TOWN OF BLUFFTON

STAFF REPORT Department of Growth Management

MEETING DATE:	January 27, 2016
PROJECT:	Cypress Ridge Entrance Design Certificate of Appropriateness Highway Corridor Overlay
PROJECT MANAGER:	Kendra Lelie, AICP Director of Growth Management

1. **COFA-01-16-9477.** A Certificate of Appropriateness to permit the entrance design for the Cypress Ridge development including new landscaping, lighting and sign installation. The Cypress Ridge entrance is located at the intersection of Highway 170 and Hulston Land Road, is zoned PUD and within the Jones Estate PUD and Cypress Ridge Master Plan.

Sheet
LP
Of 11

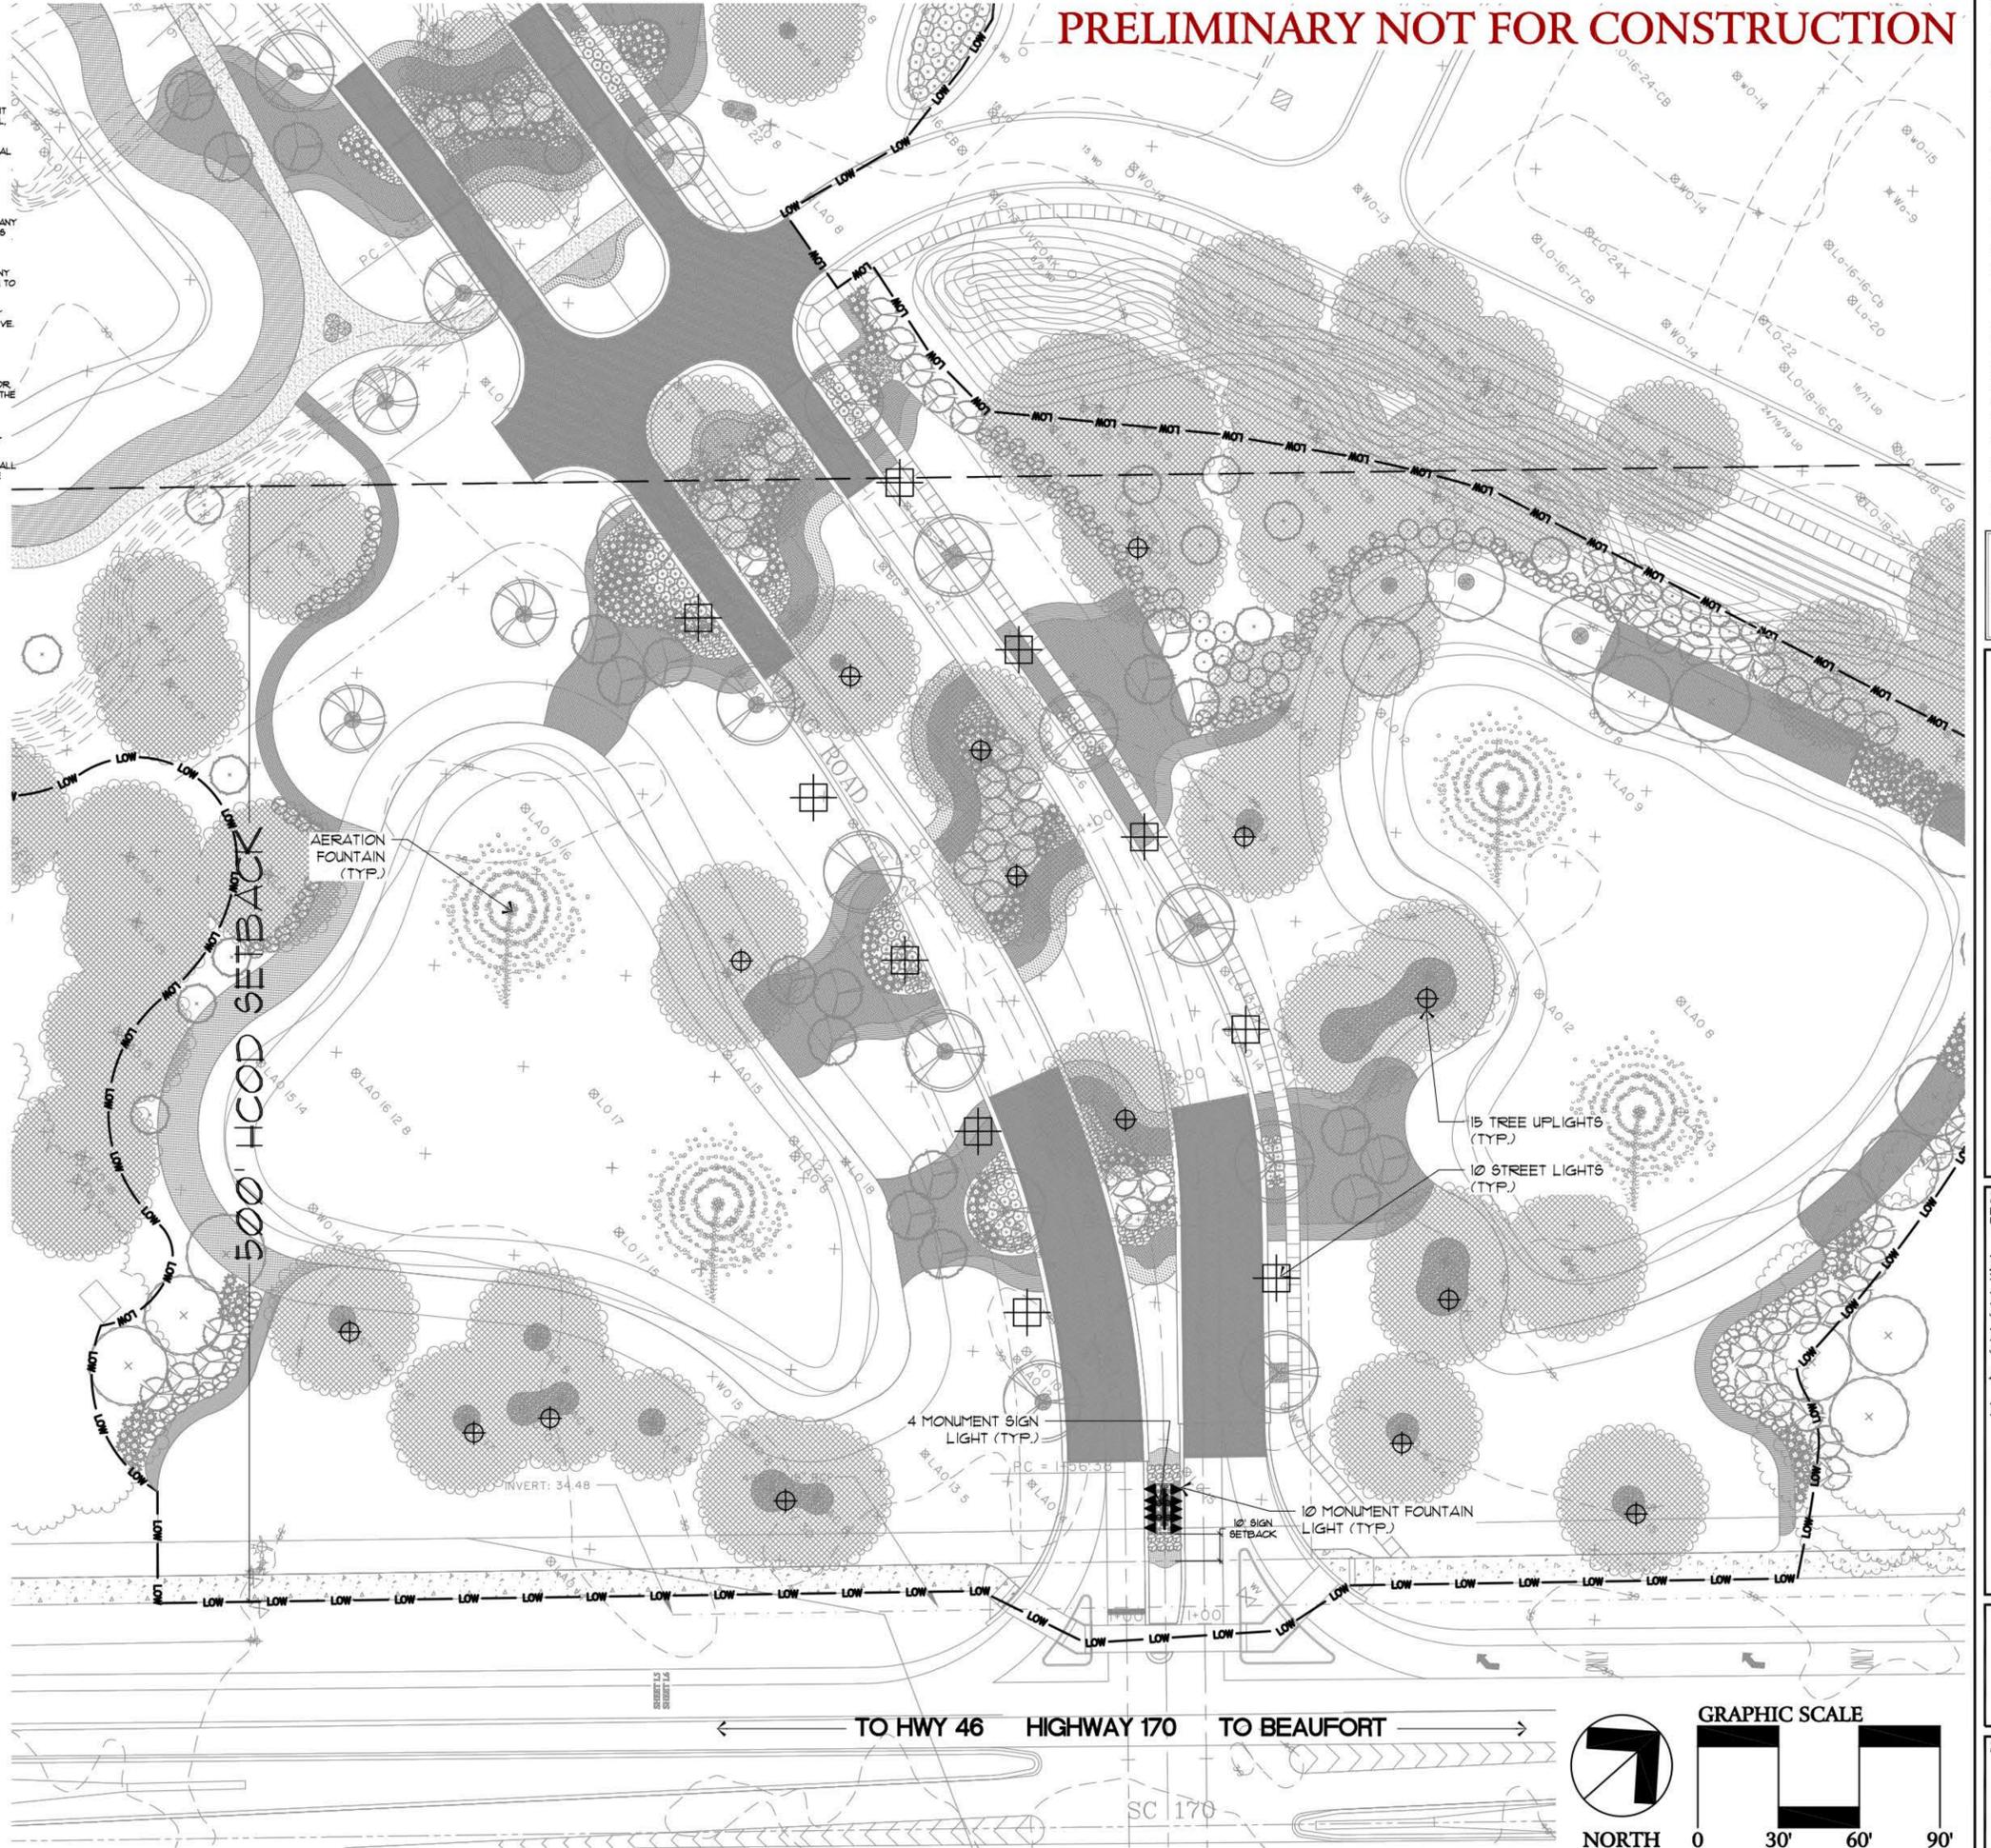
- 1) *Finding – Lighting.* Section 5.15.11 (D) of the BZDSO permits lighting for entrances to developments provided such lighting does not exceed the foot-candle requirements for lighting as provided in Section 4.23.3 (C.2.4) of the BZDSO. The lighting plan shall be revised to include foot-candle information to ensure compliance is achieved.

2. Lighting
 - a. Per Section 5.15.11 (D) of the BZDSO, provide the foot-candle illumination information to ensure compliance with Section 4.23.3 (C.2.4) of the BZDSO.
